FINAL DEVELOPMENT PLAN APPLICATION

Project/Property Address or Location: 6579 Taylor Rd.		Project Name/Business Name: Taylor Commercial Park	
Parcel ID No.(s): 027-000008-00	Zoning Designation: OCT	Total Acreage: 23	
Project Description: Two 31,050sf flex industrial buildings. Eight 7,750sf storage buildings. One 131,250 industrial building.			
APPLICANT Name -do <u>not</u> use a business name: Robert M. LeVeck		Applicant Address: 1500 W. Third Ave. Ste. 120 Columbus, OH 43212	
Applicant E-mail: rleveck@leveckconstruction.com		Applicant Phone No.: 614-582-4765	
BUSINESS Name (if applicable):			
ADDITIONAL CONTACTS: Please list Primary Contact person for Correspondence (please list all applicable contacts)			
Name(s):		Contact Information (phone no./email):	
PROPERTY OWNER Name: (if different from Applicant) Julie A. Faist		Property Owner Contact Information (phone no./email): 614-475-6677/julie.faist@gmail.com

Attn: Kelly Wicker, Administrative Assistant, kelly.wicker@gahanna.gov
RE: Project 6579 Taylor Rd Final Development Plan Comments

RE: Project 6579 Taylor Rd Final Development Plan Comment Letter

PRELIMINARY SITE PLAN FOR:
TAYLOR ROAD COMMERCIAL PARK
THE CITY OF GAHANNA

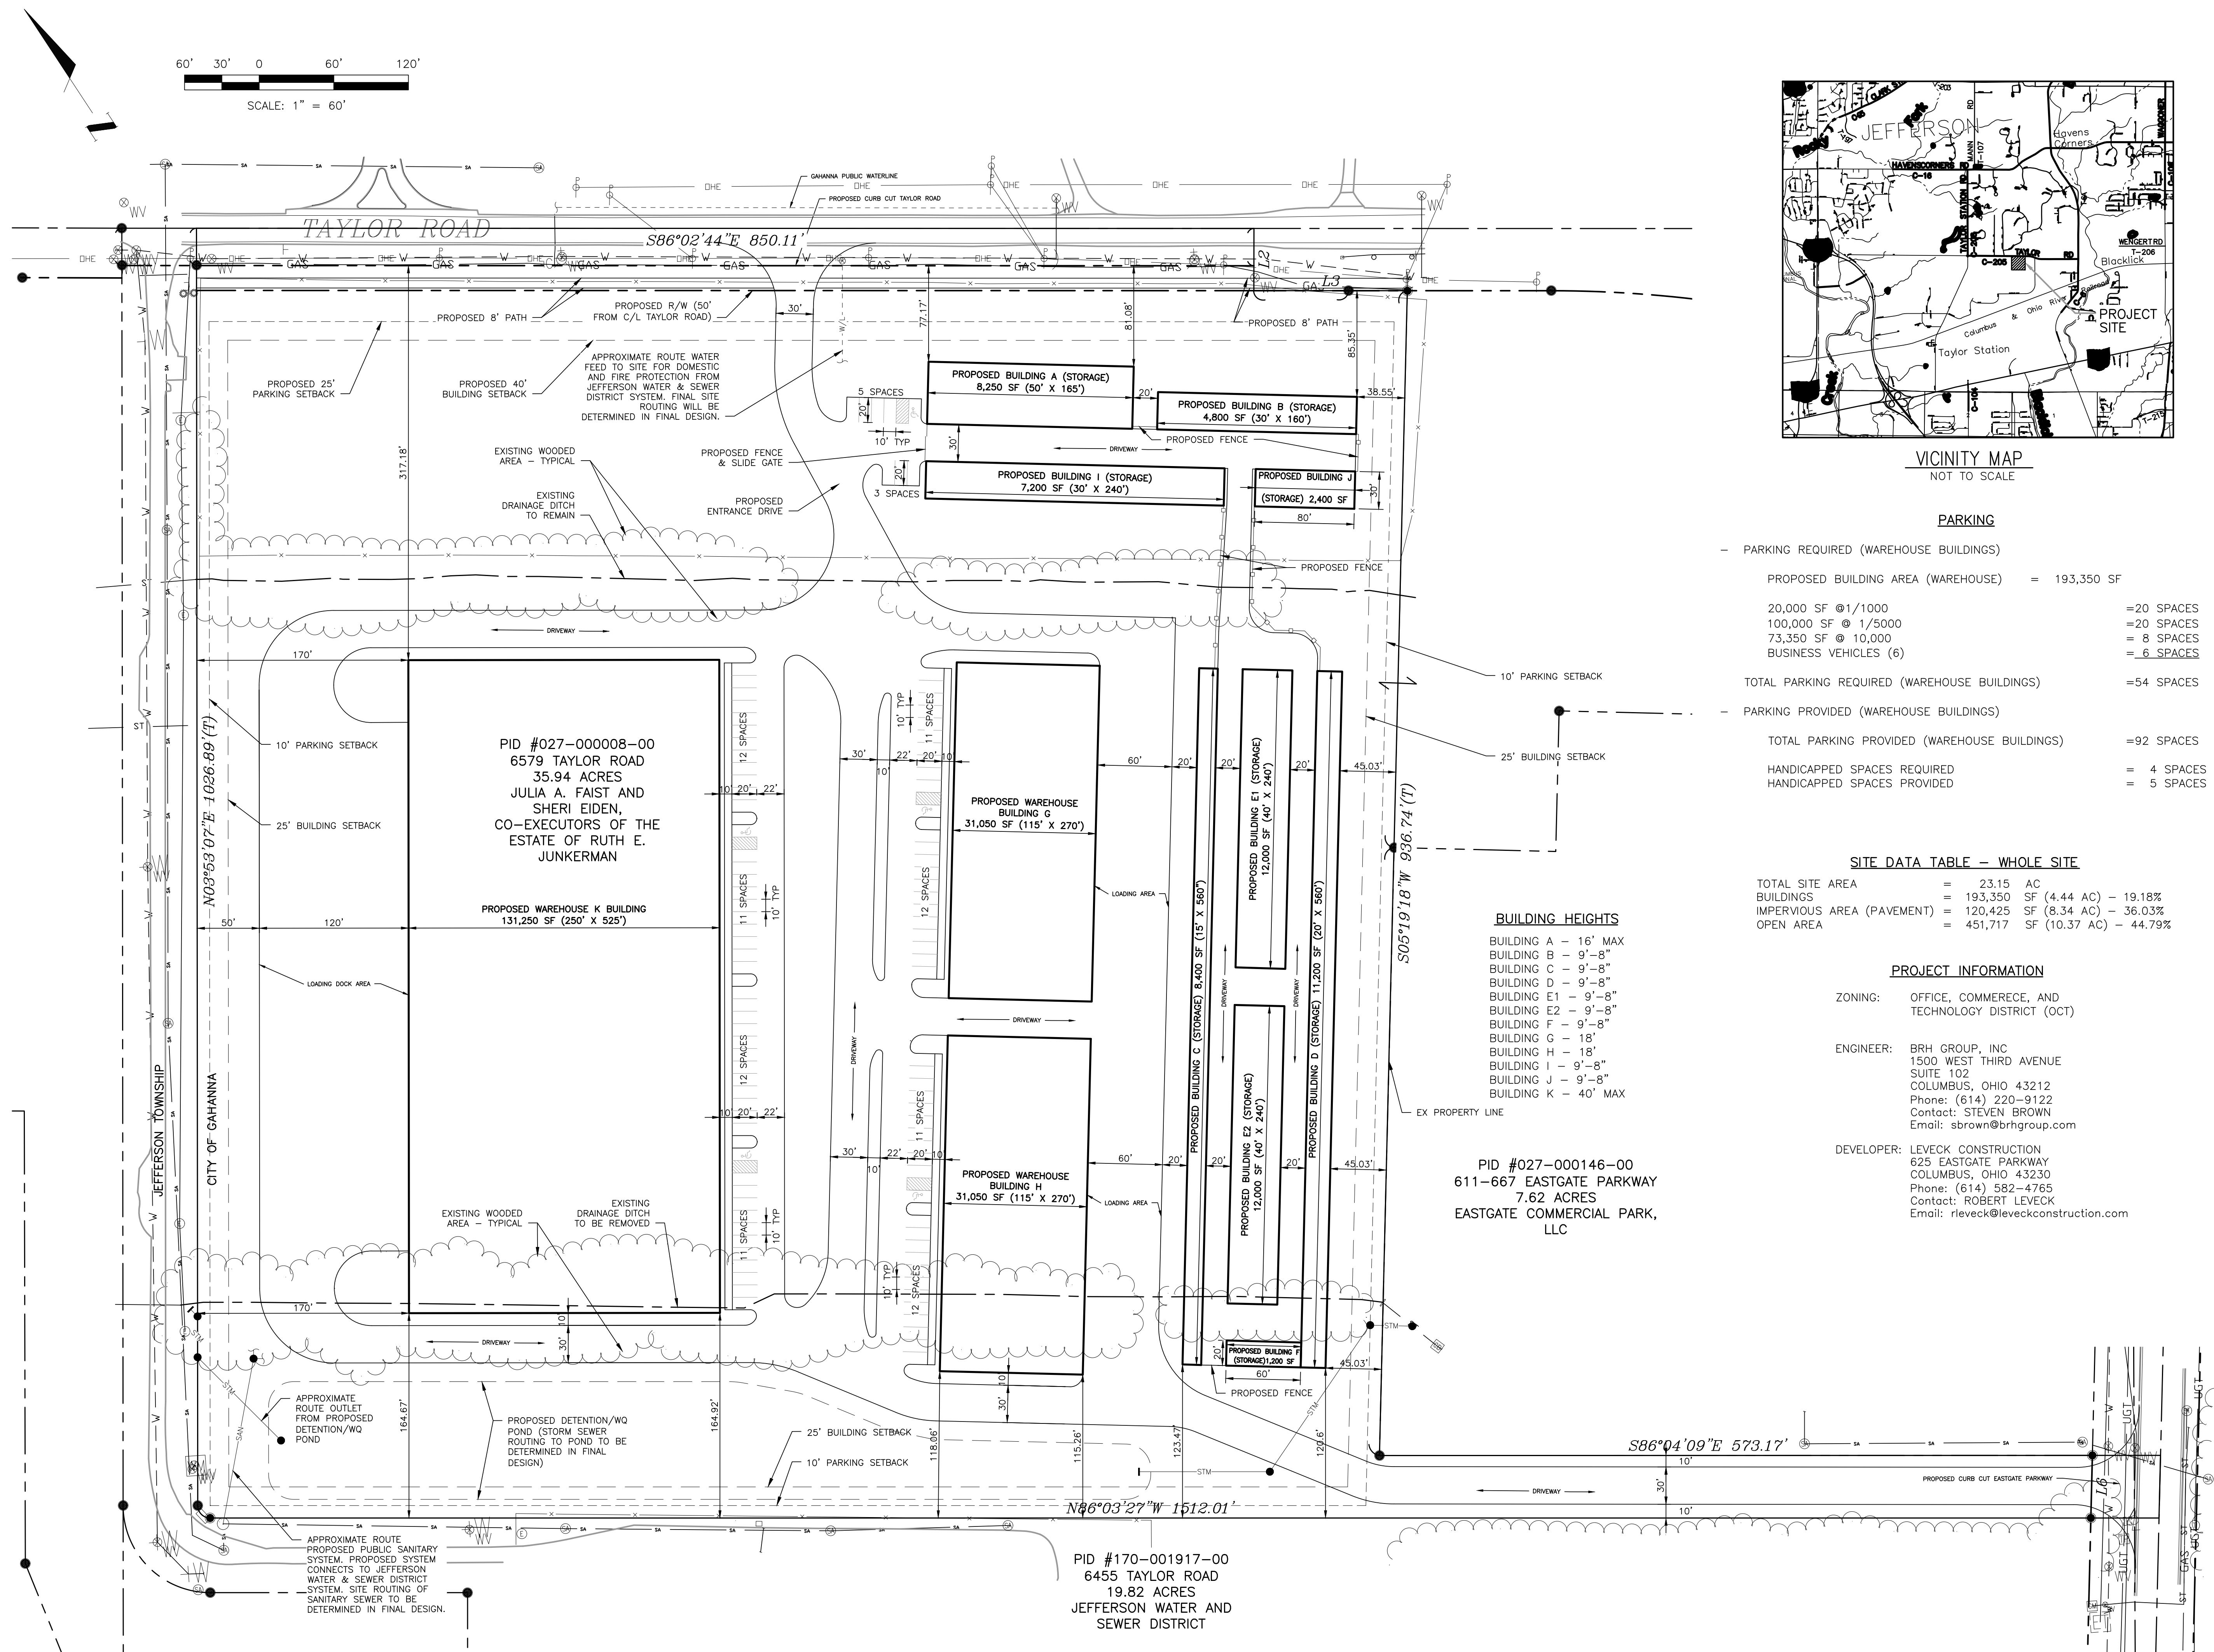
15. The site plan is difficult to read as it contains information not necessary such as contour lines and bubble clouds. Please remove unnecessary information so that the pertinent information such as building location, parking space size/location, etc. are easily reviewed. Additional comments may be forthcoming as a result.

16. 5 handicap parking spaces are depicted while the site data table states 4. Please revise accordingly.

1. None
2. Final Engineering Plan will be prepared.
3. The approximate routing of water coming to site, sanitary sewer coming to site, and detention/water quality have been shown. Final site location of all utilities will be completed in final design.

4. The Eastgate development will be routed through the proposed pond on this site as shown.
5. We have shown the dedication of 50 feet of right of way.
6. We have shown the approximate location of 8' path along Taylor Road.

7. We understand the fiber optic conduits will need to be shown on the final plans.
8. Utilities crossing Taylor road will be shown as being bored and jacked on final construction plans.

9. Fire and domestic water will come from the northern side of Taylor Road. We understand that meters, backflow protection, meter pits all acceptable to the City of Gahanna will be required.

10. None
11. Hydrants will be shown on final construction plans meeting local and national requirements.
12. None
13. Building and paving setbacks have been labeled.

14. None
15. We have removed the existing contour lines. The, "Bubbles" are edges of tree/brush lines onsite.
16. We have adjusted handicapped parking.
